Roof Inspection for : Springfield, Oregon 97478

I inspected this roof on March 7th, 2022. The roof is a new Owens Corning asphalt laminated shingle in the forest green color. Flat roofs are a GAF TPO membrane in the dark gray color. One layer over plywood. Separate photo emails will be sent. Each will be numbered to correspond with the numbered items on the summary. The following items should be noted:

ITEM 4 ON SUMMEN (Z)

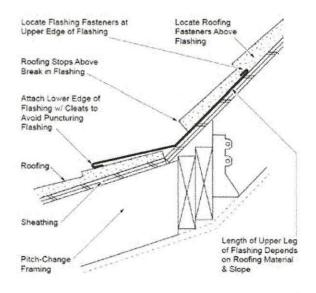
- 4. Code requires flashing at any pitch change. R903.2.1. This unique roof has dozens of pitch changes. I contacted Owens Corning twice about this. See attached correspondence from them. I also contacted Eric McMullen who is a Senior Building Code Specialist for the Oregon Building Codes Division. Occasionally I contact Eric if I need absolution. See attached emails from Eric.

Code typically requires flashing to be installed at all pitch changes on a roof plane.

If flashing is not used then shingles require face nailing. The Framing many times is rough and will cause buckling or pounding in shingles.

The angle change are subject to leaking and other roof issues.

Owens Corning would recommend the following.

Convex angle changes should always be flashed with a 24 gage sheet metal L flashing bent to match roof planes.

A corrosive resistant sheet metal bent to match roof planes.

SA underlayment ASTM 1970 18" to 36" wide. This ice and water barrier should be shingle lapped on top of the head-lap of shingles below.

Metal Flashing. Attach lower edge of flashing with cleat. A cleat should be 24 gage or thicker to prevent wind up lift. Other option is use screws with washer and rubber gasket no less 12" on center

Fasten cleat 4" on center with roofing nail or pan head screw Cleat 24 gage sheet metal or greater.
Roofing material not shown for clarity
